**City of Portland, Maine – Building or Use Permit Application** 389 Congress Street, 04101, Tel: (207) 874-8703, FAX: 874-8716

**BUILDING PERMIT REPORT**

DATE: 11 APRIL 2000 ADDRESS: Lot #25 Auburn Pines CBL: 386A-B-025  
REASON FOR PERMIT: Single Family dwelling with attached garage  
BUILDING OWNER: Dona Telle  
PERMIT APPLICANT: \_\_\_\_\_ / CONTRACTOR owner  
USE GROUP: R-3 CONSTRUCTION TYPE: 5-B CONSTRUCTION COST: 170,000.00 PERMIT FEES: 864.00

**CITY OF PORTLAND, ME  
BOCA 1999 Plan Review Record  
One and Two Family Dwelling**

FIRST FLOOR PLAN - D.D.

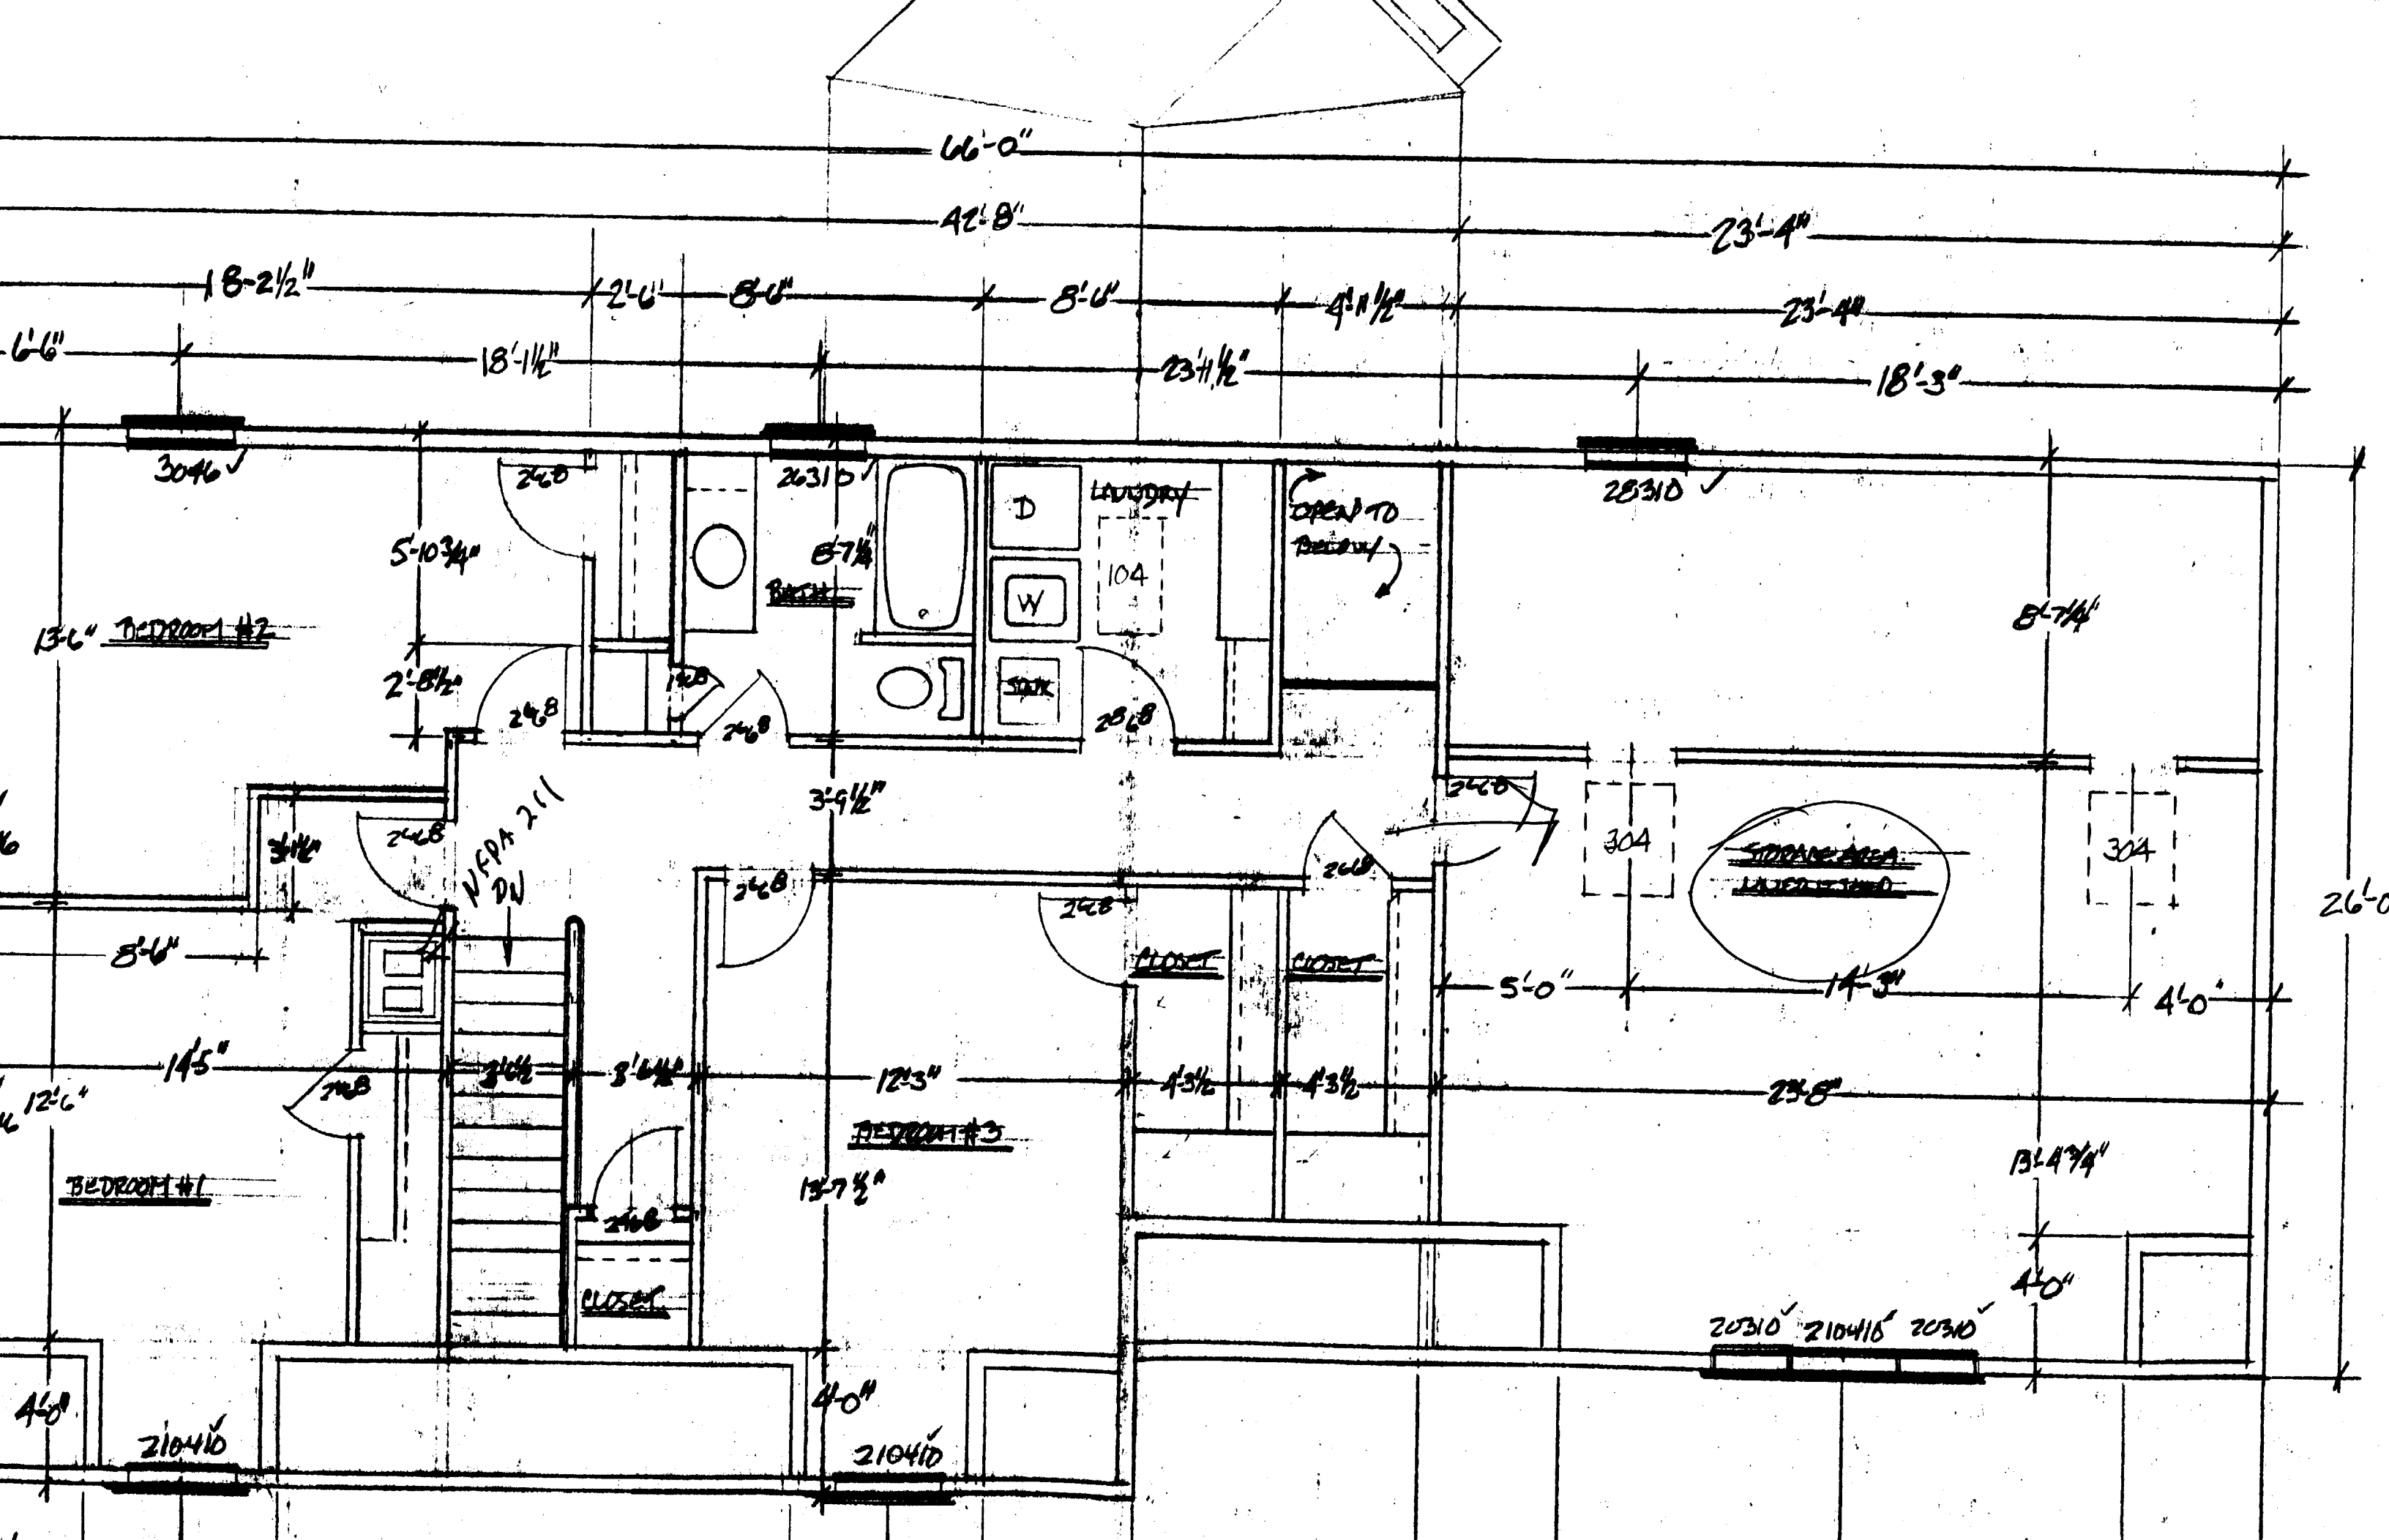
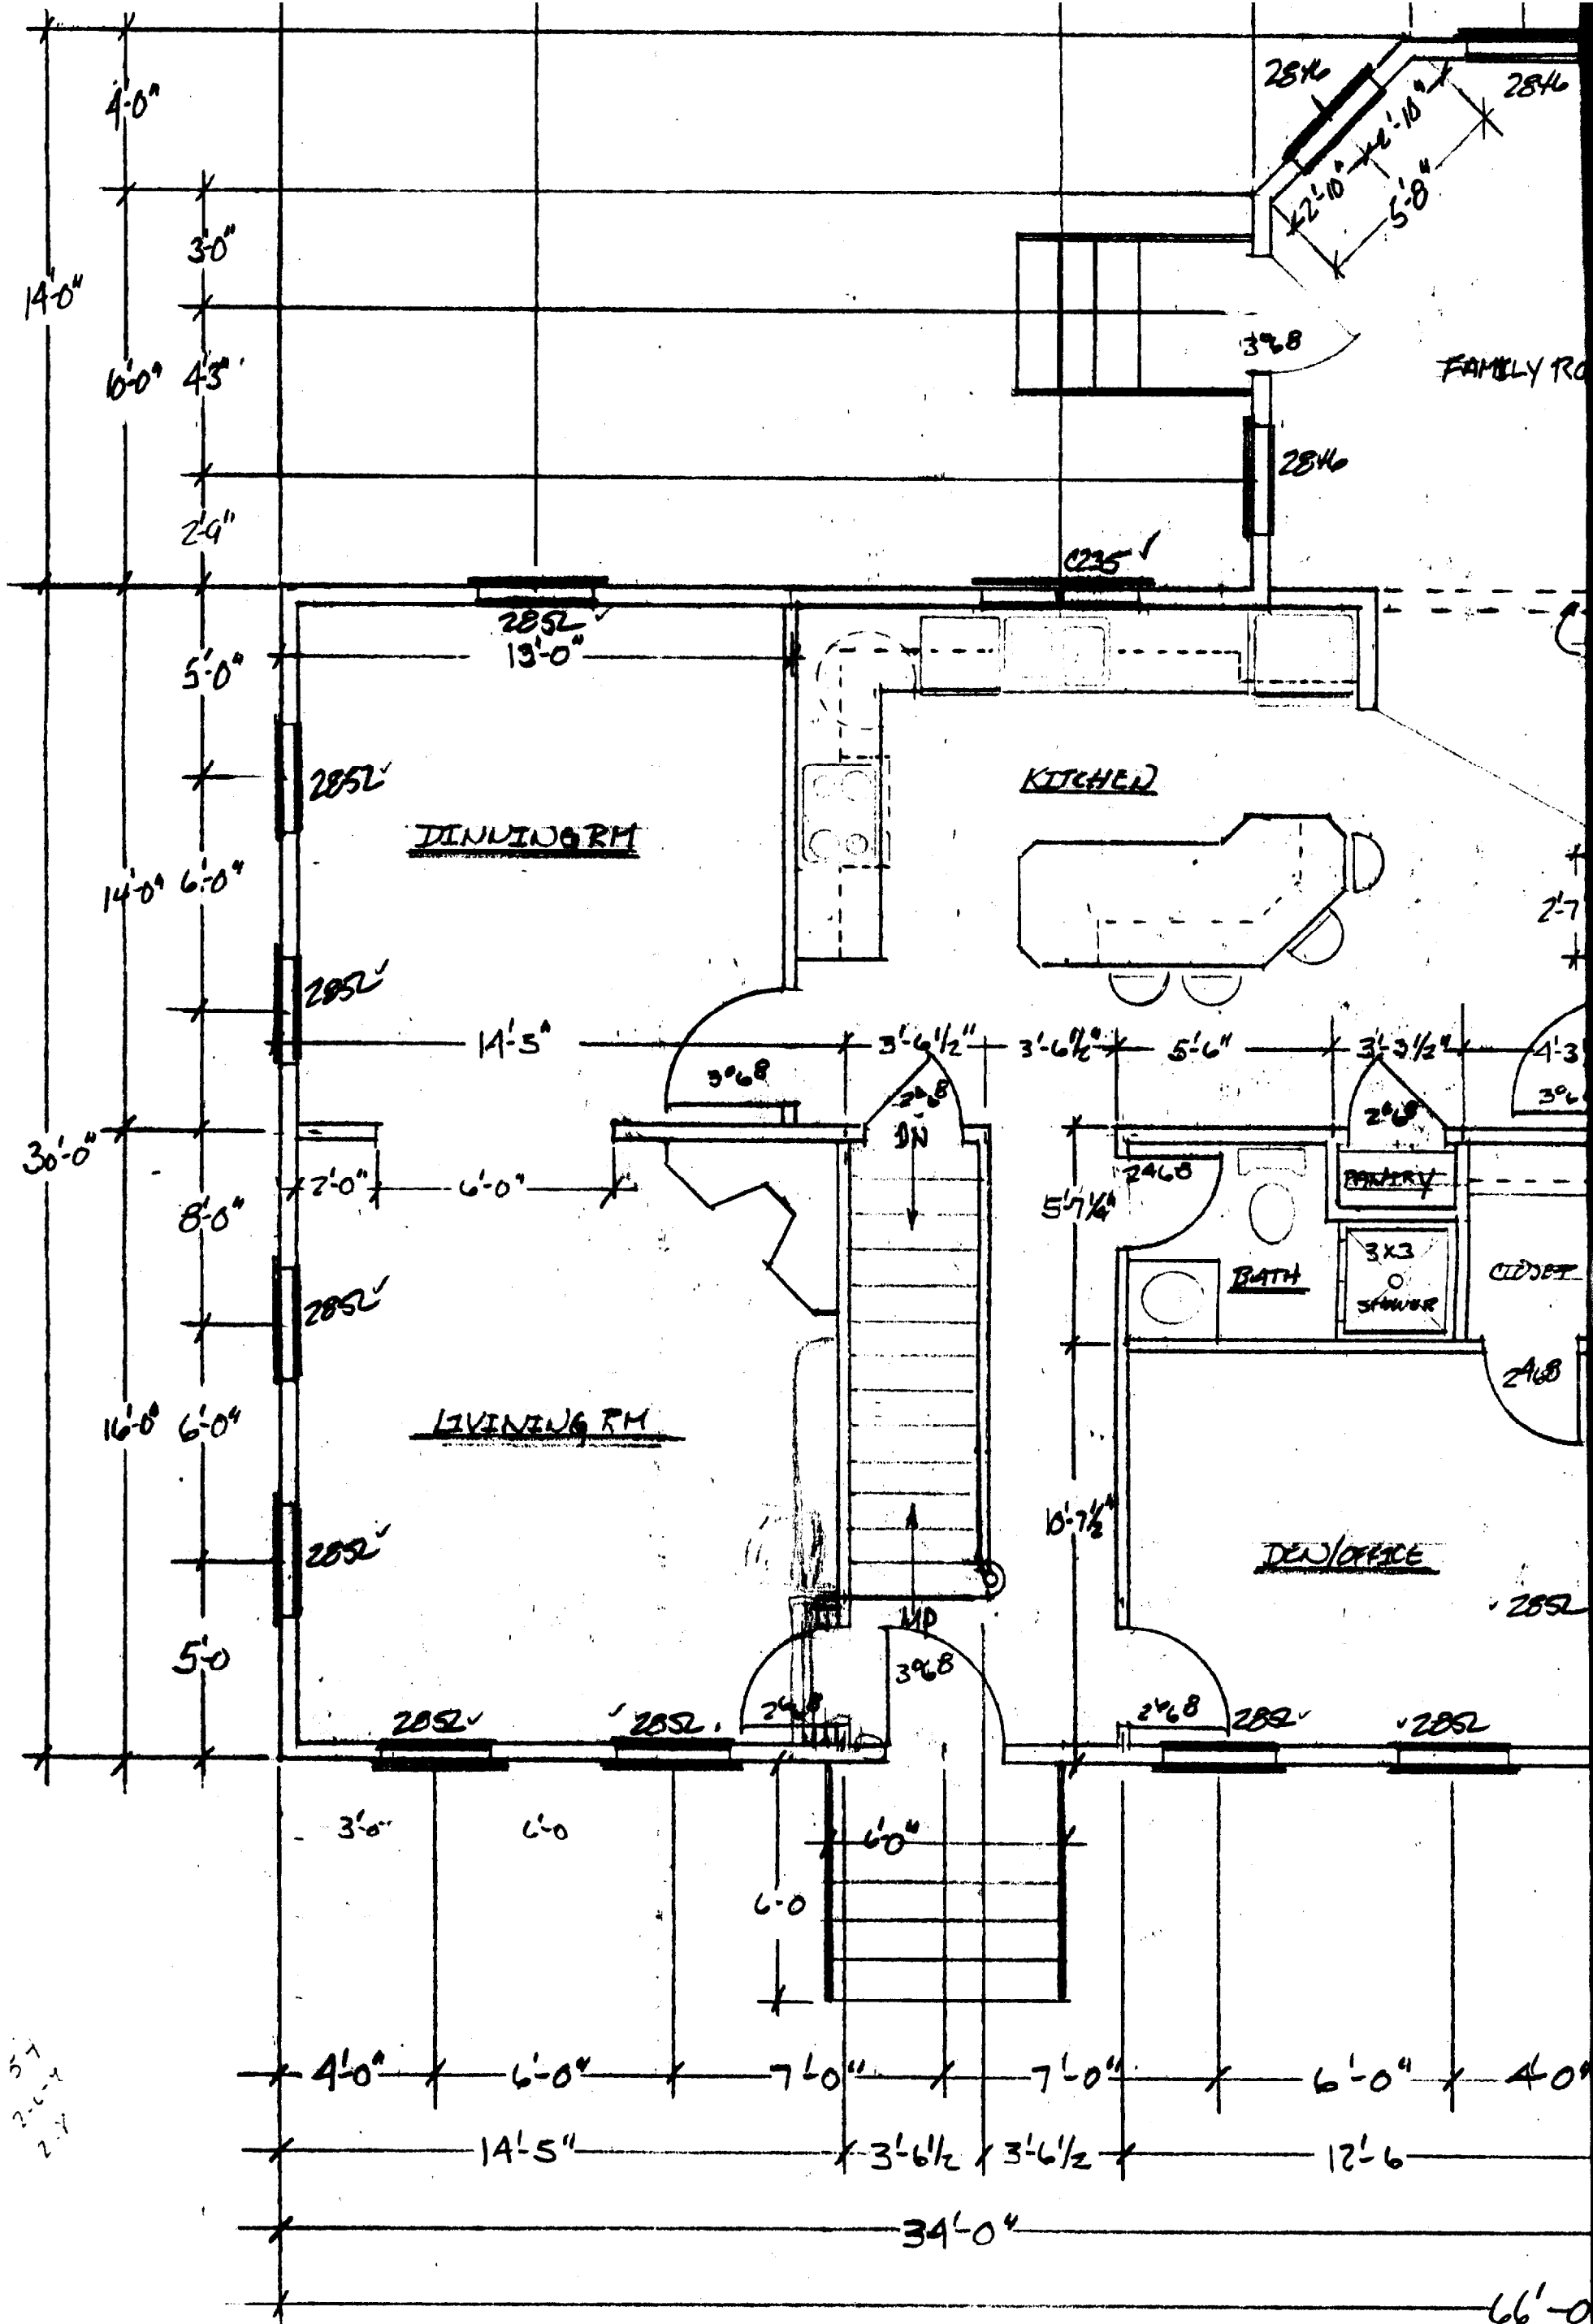
Guards rails  
hand rails.
